U.S. Department
Of Transportation
**Federal Highway
Administration**

March 14, 1996

Refer to: HNG-14/SS-56A

Enclosure
Supplement to Geometric and Roadside Design Acceptance Letter SS-56A

LAP SPLICE BAR SPACER

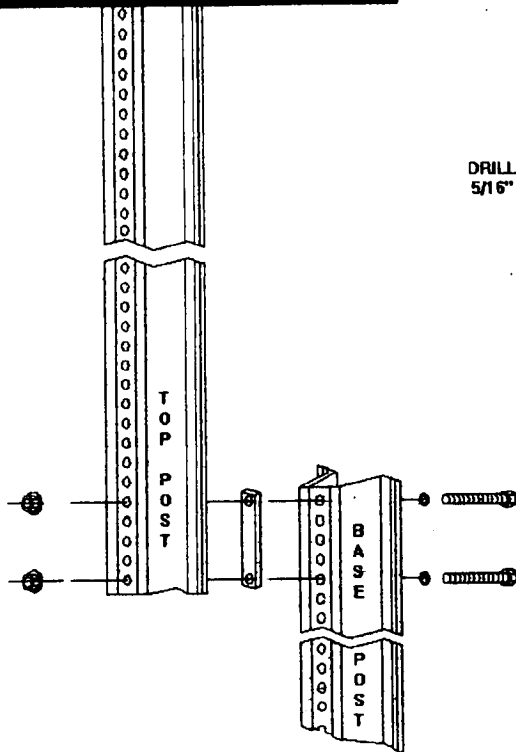
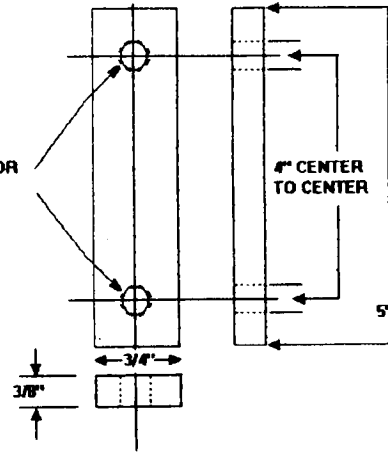
The proposed modification would replace the threaded spacers used with each of the two connecting bolts with a single bar of steel, drilled and tapped with threaded holes 4 inches (102 mm) apart. The spacer bar will be 3/8-inch (9.5-mm) thick, as were the individual spacers used in the crash tests. A drawing of the Lap Splice bar spacer is enclosed.

We concur that the spacer bar will cause no significant change to the breakaway performance of the lap Splice system and that no additional crash testing will be required. Therefore, your company's breakaway Lap Splice system with the spacer bar will be acceptable for use on the National Highway System when requested by a State. All other conditions in our July 13, 1995, letter remains in effect.
